PROJECT **WATERVUE**
643-651 HUNTER STREET NEWCASTLE NSW 2300

DRAWING No. DA011
DRAWING TITLE PLANNING - GFA
SCALE 1 : 250 @ A1
DATE 2023

DEVELOPMENT APPLICATION SHEET LIST		
DRAWING NO.	TITLE	REVISION
DA000	PLAN - LOCATION & DRAWING SCHEDULE	H
DA002	SITE ANALYSIS	B
DA003	PREDICT LOCATION PLAN	C
DA005	SITE PLAN	C
DA006	SHADOW DIAGRAMS	B
DA007	SHADOW DIAGRAMS	B
DA008	SHADOW DIAGRAMS	A
DA009	SOLAR ACCESS DIAGRAM	B
DA010	VENTILATION DIAGRAMS	B
DA011	PLANNING - GFA	G
DA012	UNIT AREA FOR CARPARKING GEN.	D
DA101	GROUND FLOOR	I
DA102	PARKING LEVEL 1	G
DA103	PARKING LEVEL 2	F
DA104	PARKING LEVEL 3	F
DA105	PLAN - PODIUM	H
DA106	PLAN - TYPICAL LOWER	G
DA107	PLAN - TYPICAL UPPER	F
DA111	PLAN - PENTHOUSES	C
DA112	ROOF	B
DA200	STREETSCAPE ELEVATIONS	B
DA201	ELEVATIONS - NORTH AND EAST	F
DA202	ELEVATIONS - SOUTH AND WEST	C
DA301	SECTIONS	C
DA321	RAMP SECTION CARPARK	C
DA401	PERSPECTIVE	B
DA402	PERSPECTIVE	B
DA403	PERSPECTIVE	B
DA409	MATERIALS + FINISHES	B
DA801	PODIUM LEVEL PRIVACY SCREENS	A
DA802	SIGNAGE DESIGN INTENT	A

DRAWING No. **DA002**
DRAWING TITLE **SITE ANALYSIS**
SCALE
DATE **2022**

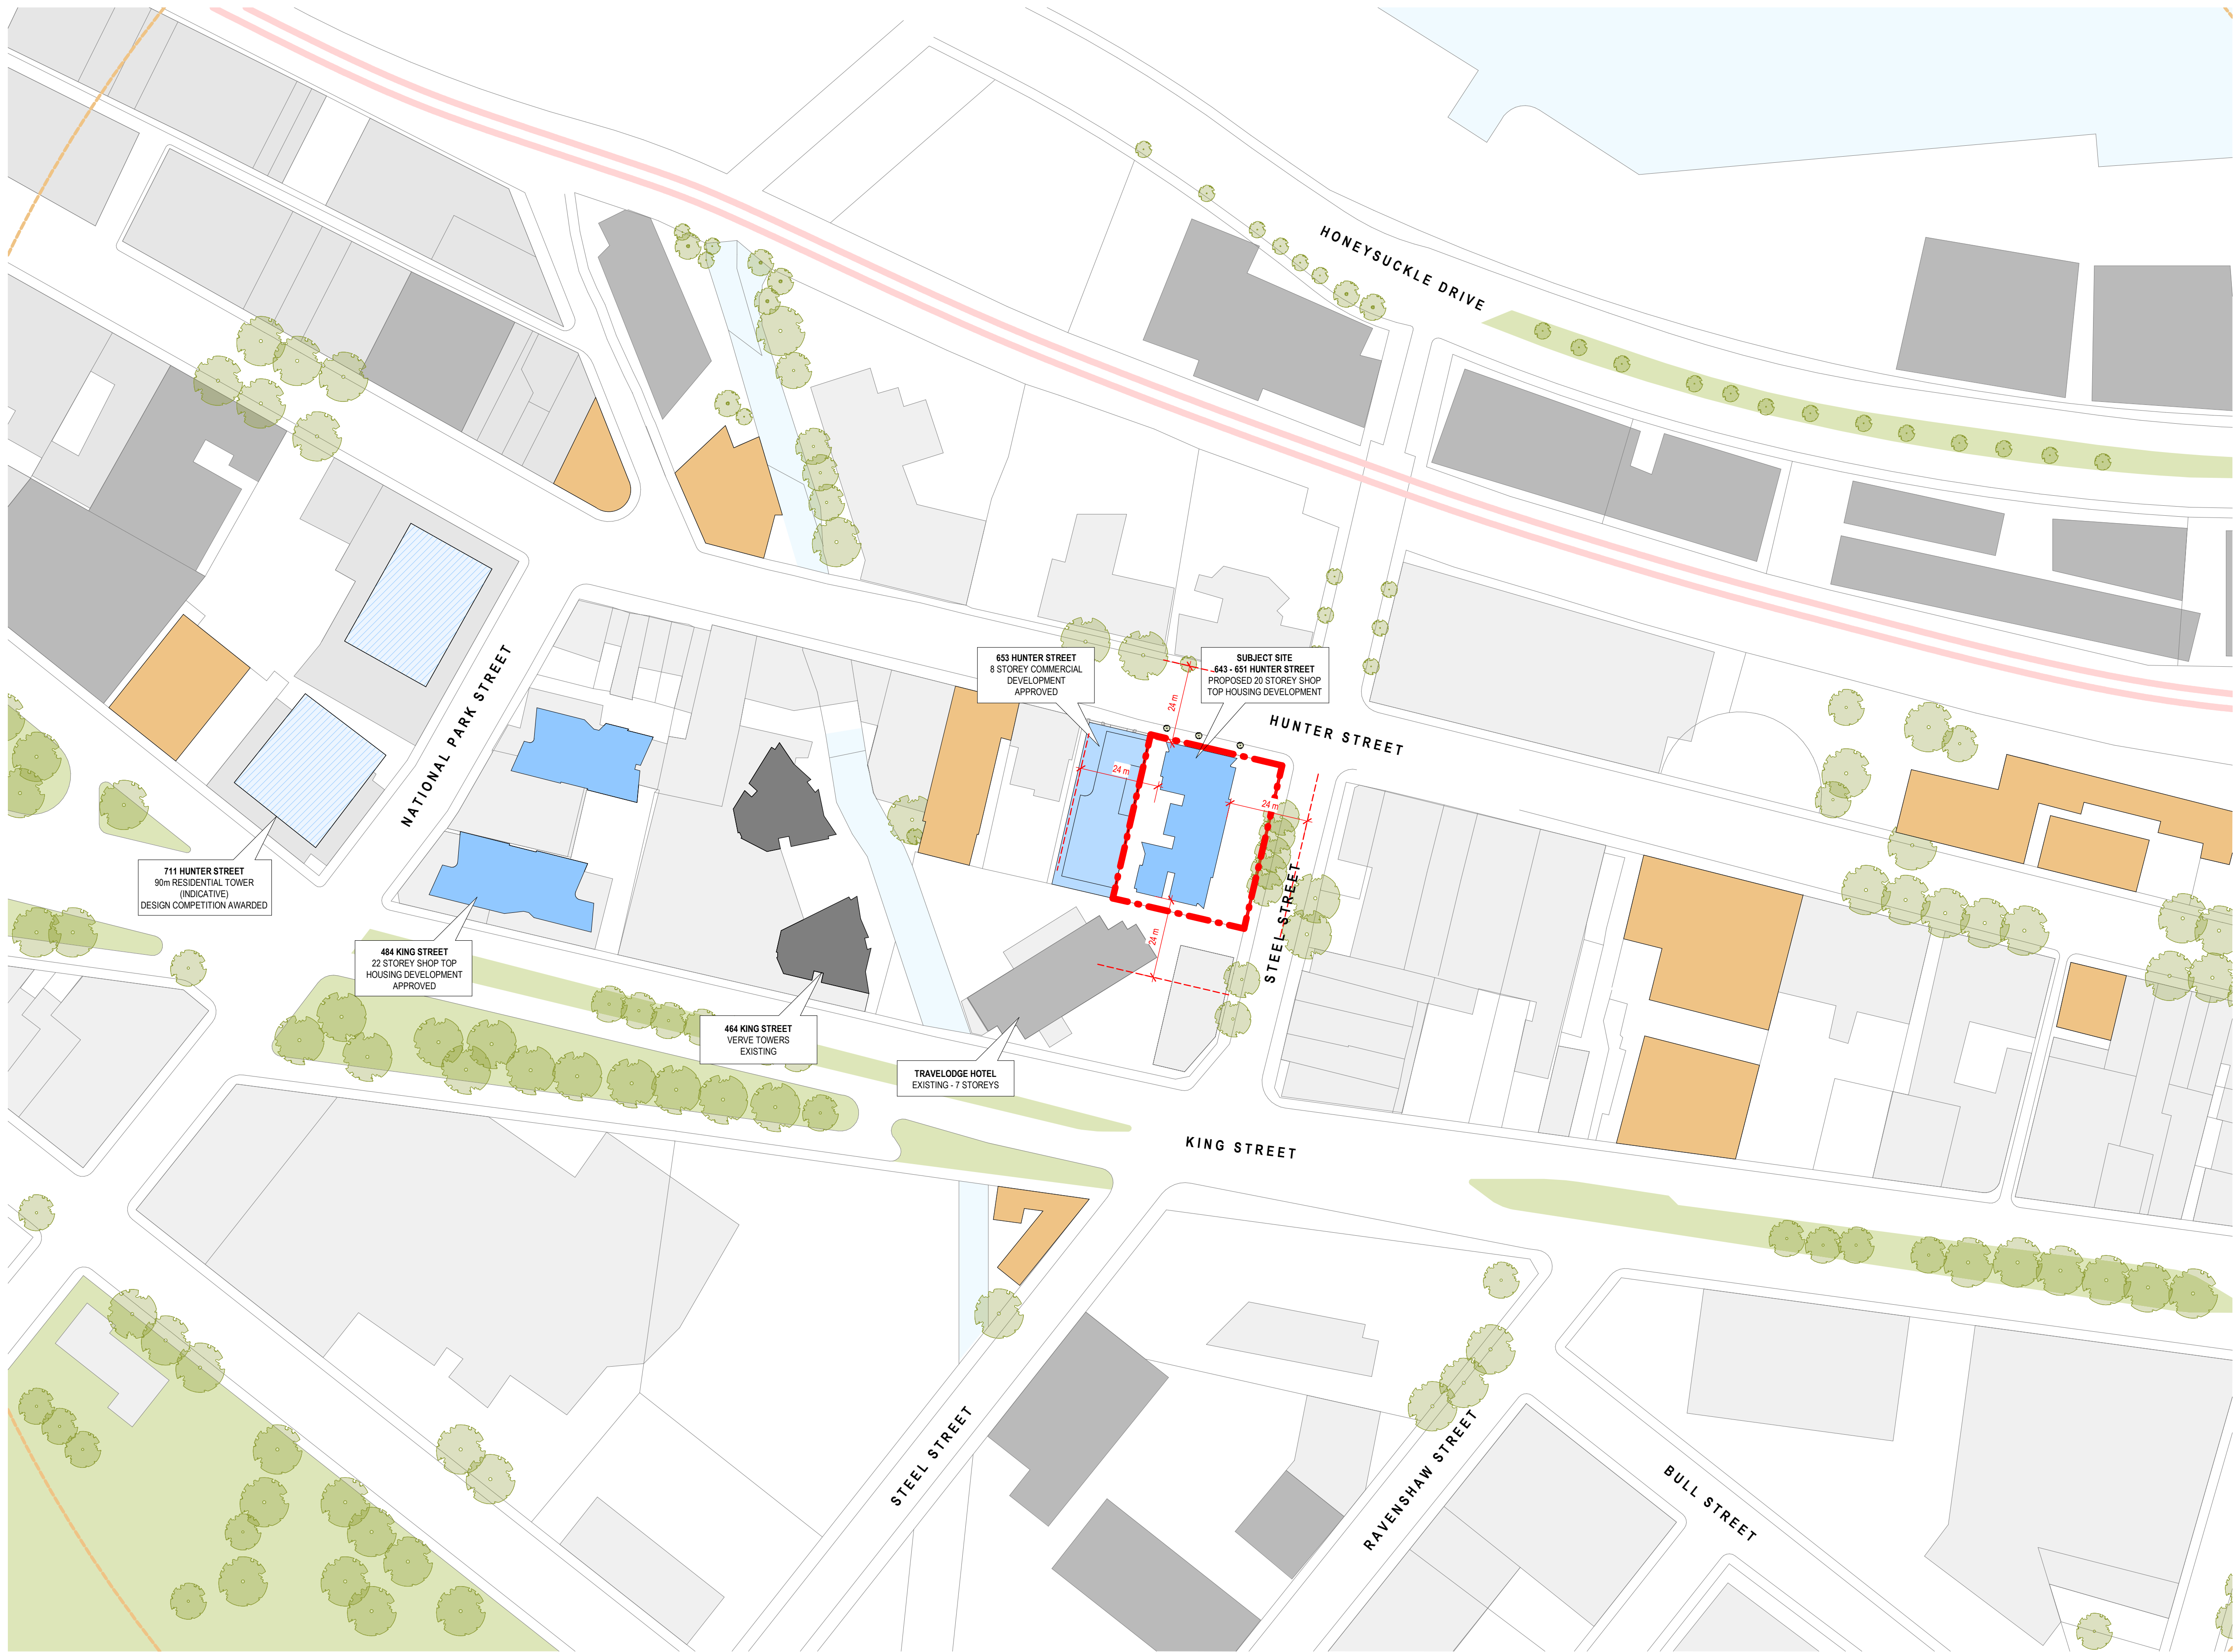
DA RfIs - 27.03.2023
24m BUILDING SEPARATION LINE ABOVE 45m INDICATED
PRIVACY SCREEN LOCATION CLARIFIED
